Ritron Model(s):	LM-700DMR and RIB-700DMR
Current Firmware Revision:	47.22
Revision Update:	Feb 10, 2024; Jul 8, 2025 updated

LM-700DMR and RIB-700DMR Firmware Revision and Update History

47.22 released: 9S1N4722.hex 2/10/2025; Jul 8, 2025 updated

R614 vs. V22/V21

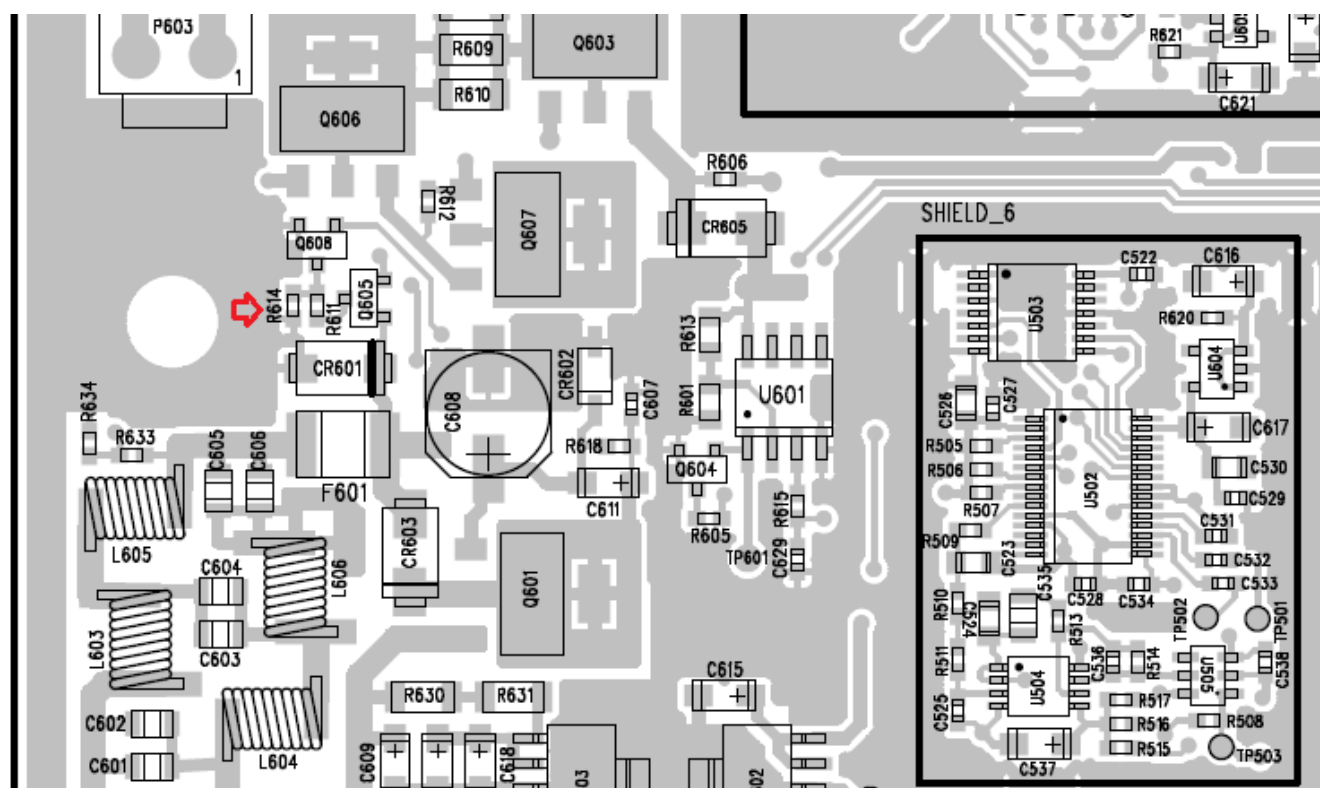
- Added a feature that the unit can auto shutdown when 12V external power is lost and the battery is below 9.5V for at least 5 seconds. Before auto shutdown, the unit will beep 3 times. It is to prevent internal backup battery from over draining. To enable this feature, R614 (0 ohm) has to be removed. R614 was populated on the early units. With V22, if R614 is not removed, the unit will still work like V21, the battery dead auto shutdown just does not work. For the old version firmware, V21 and earlier, if R614 is depopulated, the battery backup function will stop working. i.e. depopulated R614 needs V22 or newer f/w to make the battery backup function work.

Updated: Added above R614 part locator on Jul 8, 2025.

R614	Depopulated (new built)	Populated (old built)
F/W V22 and newer	Dead battery auto shutdown (lower than 9.5V) enabled	Dead battery auto shutdown (lower than 9.5V) is disabled, Same as V21 or older
F/W V21 and older	Battery backup function will stop working	Dead battery auto shutdown (lower than 9.5V) is disabled
